Informal document GRSP-64-16-Rev.1  
(64th GRSP, 11-14 December 2018  
agenda item 19)

# Introduction of Booster Cushions in R129

Clepa Proposal for R129/04 Series of Amendments  
GRSP 64th Session  
Farid Bendjellal

## Stature limitation

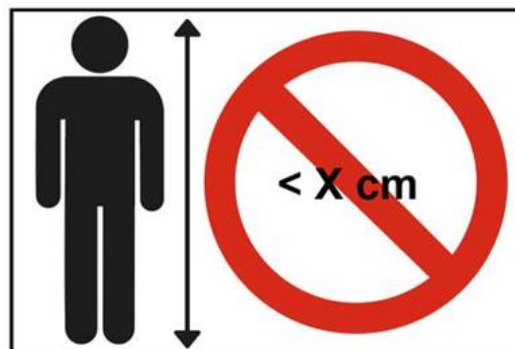
The following label from R44 was carried over, but modified to inform the consumer that booster cushions shall only be used above a stature declared by the manufacturer.

**4.8.5. *Booster cushion Enhanced Child Restraint Systems shall have the following label (Minimum size: 60 x 40 mm) a permanently attached and visible to the person installing the Enhanced Child Restraint System in the car.***

***The limit X shown on the label represents the lower stature of the size range the Enhanced Child Restraint System is approved to. If the booster cushion is approved in combination with a booster seat the label shall be visible only when the ECRS is used as a booster cushion.***

B2 fixture

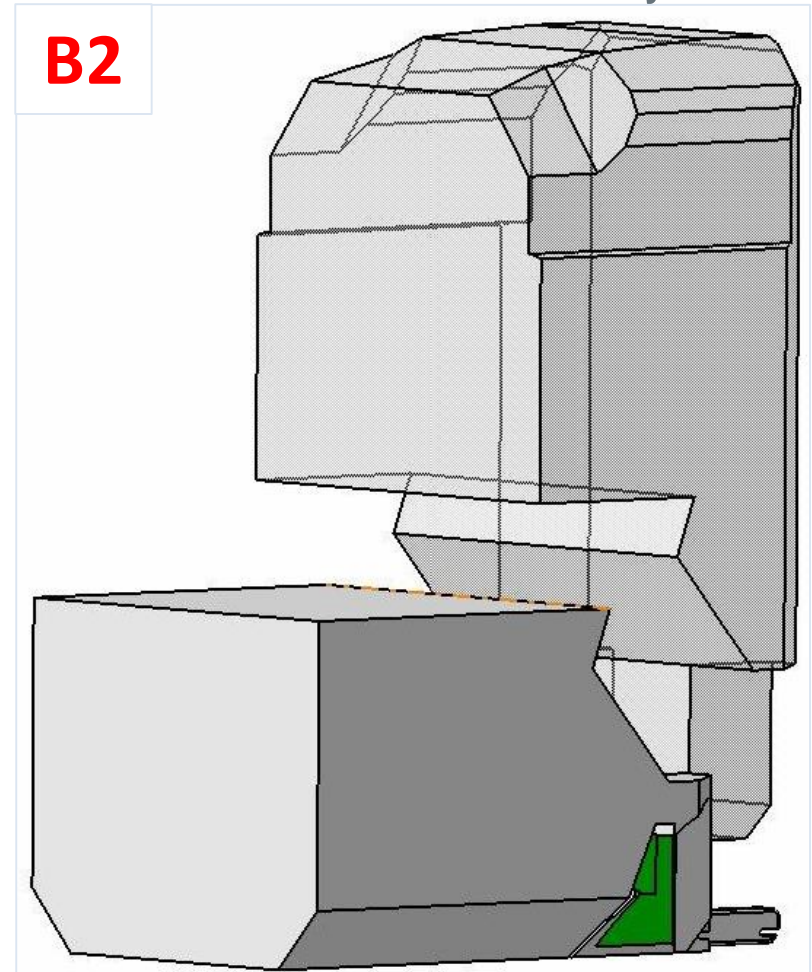
The requirement which envelope has to be fulfilled is extended for booster cushions to fit into the B2. The explanation for adjustment was limited to booster seats only.

*The maximum external dimensions for the width, height and depth of the Enhanced Child Restraint System and the locations of the ISOFIX anchorages system if any, with which its attachments shall engage, shall be defined by the i-Size booster seat fixture as defined in paragraph 2.17.2. of this Regulation.*

- (a) i-Size booster cushion Enhanced Child Restraint Systems shall fit within the ISO/B2 size envelope;*
- (b) Specific vehicle booster cushion Enhanced Child Restraint Systems shall fit:
  - (i) In vehicle(s) specified in a list; or*
  - (ii) At least in one of ISO/B2 or ISO/B3 size envelope as described in Annex 17, Appendix 5 of regulation No. 16.**

Figure 1  
Sitting height check measurement device

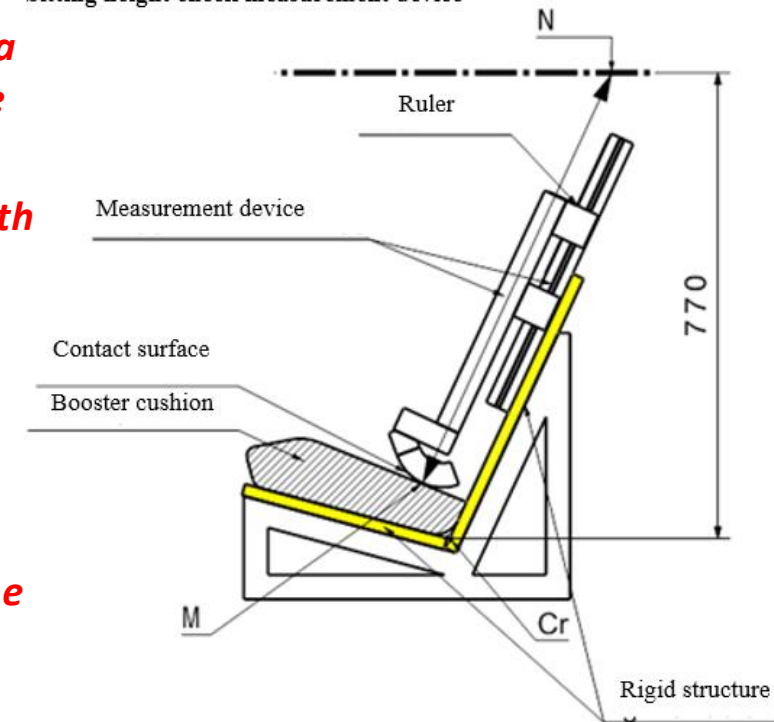
- (e) *The measurement device is extended downwards parallel to the simulated test bench backrest, until it is stopped by the booster seat cushion.*

**(f) The measured distance between the two points M and N represents the sitting height of a child who will use the cushion represented in Figure 1. The corresponding value is displayed by a ruler that is provided with the device as shown in Figure 2.**

## **Annex 25**      **Measurement device for booster cushion height check**

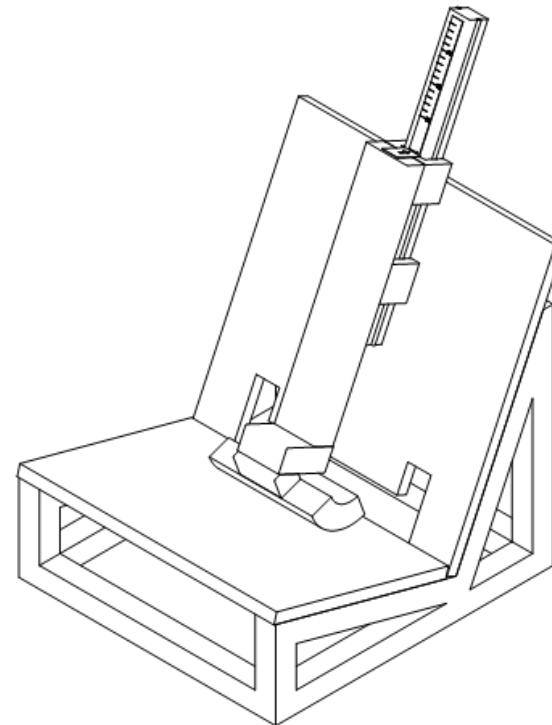
The following device is proposed to be used to check if the booster cushion provides the required height for the claimed stature.

Figure 1 Arrangement for testing a forward-facing device

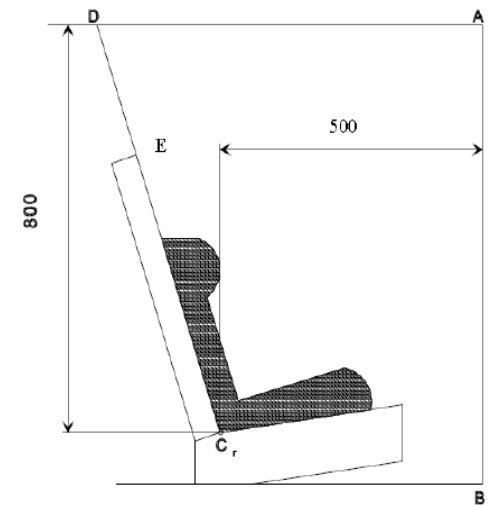
Head excursion: No part of the head of the dummy shall pass beyond the planes BA, DA and DE as defined in Figure 1 below. This shall be judged up to 300 ms or the moment that the dummy has come to a definitive standstill whatever occurs first. **Except for booster seats and booster cushions** when testing using Q10 dummy the following apply:

- (a) The value in relation to the DA plane is 840 mm; and
- (b) The value in relation to the BA plane is 550 mm; and
- (c) The rebound phase is not considered for the assessment of the plane DA and DE.

**For booster cushions the following also apply when testing with a Q6:**

- (d) The rebound phase is not considered for the assessment of the plane DE**

**Figure 1**

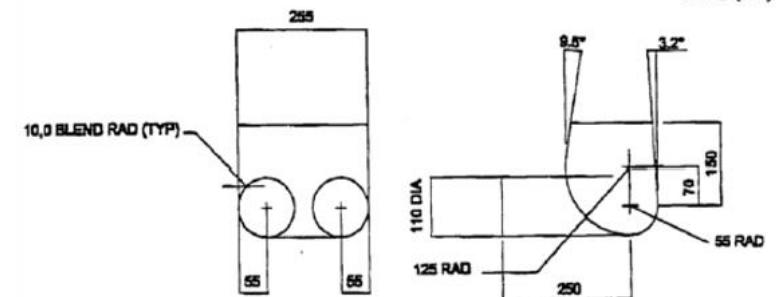
**Place a cotton cloth on the seating surface of the test bench. Position the booster cushion on the test bench, position the lower torso body block as described in Annex 26, Figure 1, on the seating surface, fit and apply the 3-point adult safety-belt and tension as prescribed in paragraph 7.1.3.5.2.2. With a piece of 25 mm width webbing or similar tied round the booster, apply a load of  $250 \pm 5$  N in the direction of arrow A, see Annex 26, Figure 2, in line with the seating surface of the test bench.**

**It should not be allowed that the booster cushion is completely pulled out under the lower torso body block.**
